PCII Request / Re-assessment

< MU709s-6 >, FCC ID: < QISMU709S-6 > granted on < 2015-1-15 >

Differences between the MU709s-6 (LGA) and the MU709s-6 (PCIE)

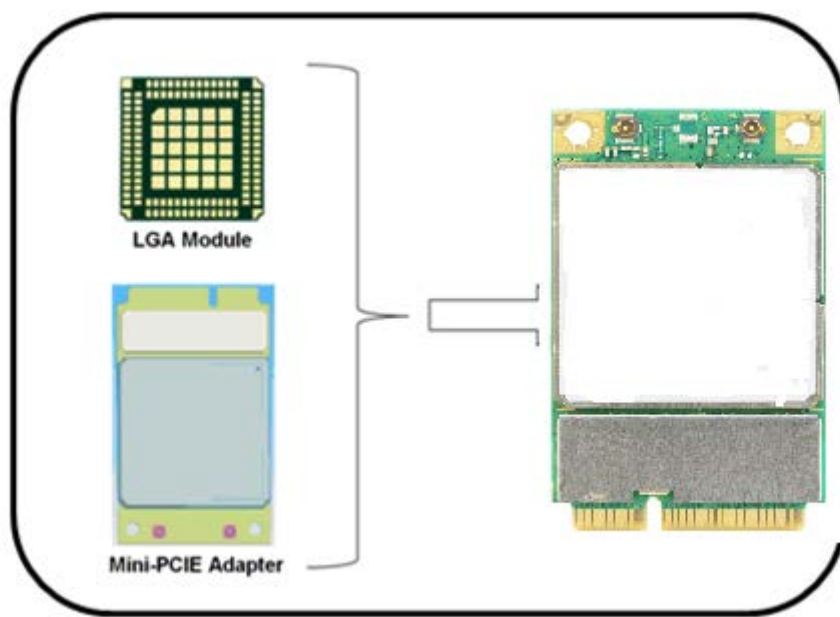
- No hardware changes in RF part
- Modification in the host interface as described below

There is the same hardware and software between the MU709s-6 (LGA) and the MU709s-6 (PCIE). The only interface changes from LGA to PCIE.

The differences between the MU709s-6 (LGA), the MU709s-6 (LGA) and the MU709s-6 (PCIE) have been listed in following table:

The new MU709s-6	The old MU709s-6
Working bands	The same	The same
Power Voltage	3.0 V to 3.6V (3.3 V is recommended.)	3.3 V to 4.2 V (3.8 V is recommended.)
Interface	PCIe interfaces	145-pin LGA interface
Hardware	The same	The same
